Airworthiness Directive

AD No.: 2015-0119

A330 and A340 aeroplanes

ATA 35 – Oxygen – Chemical Oxygen Generators – Replacement

Appendix 1 – Passenger Oxygen Generator Date of Manufacture

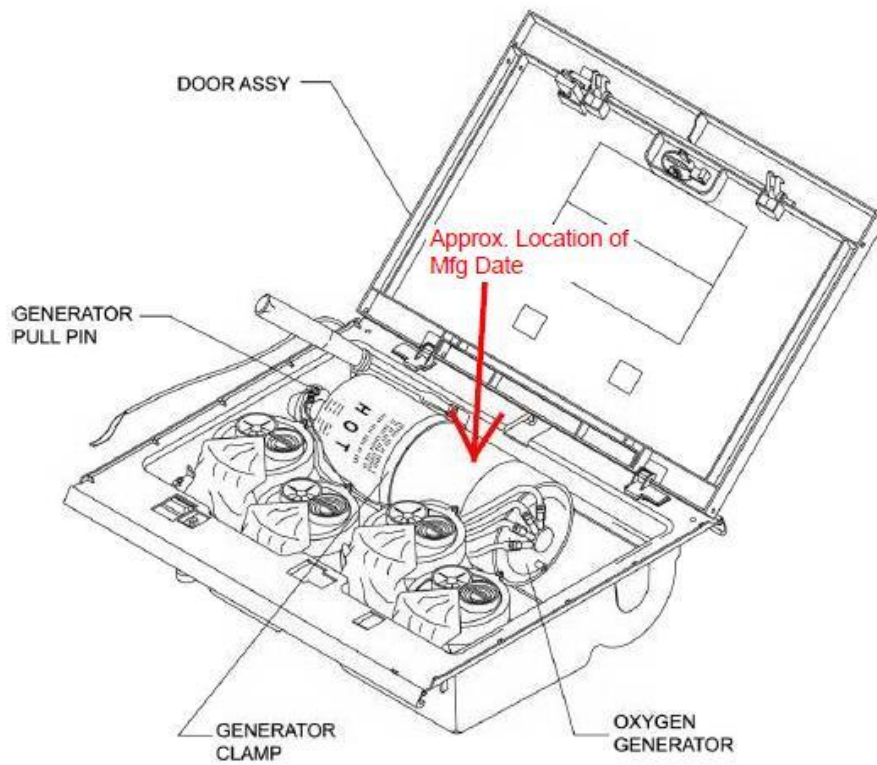
- (1) Within 30 days after 24 December 2014 [the effective date of EASA AD 2014-0277], identify the date of manufacture (see Appendix 1 of this AD where this is located) of each oxygen generator, having a P/N as listed in Table 1 of this AD, in accordance with the instructions of Airbus AOT A35L007-14.
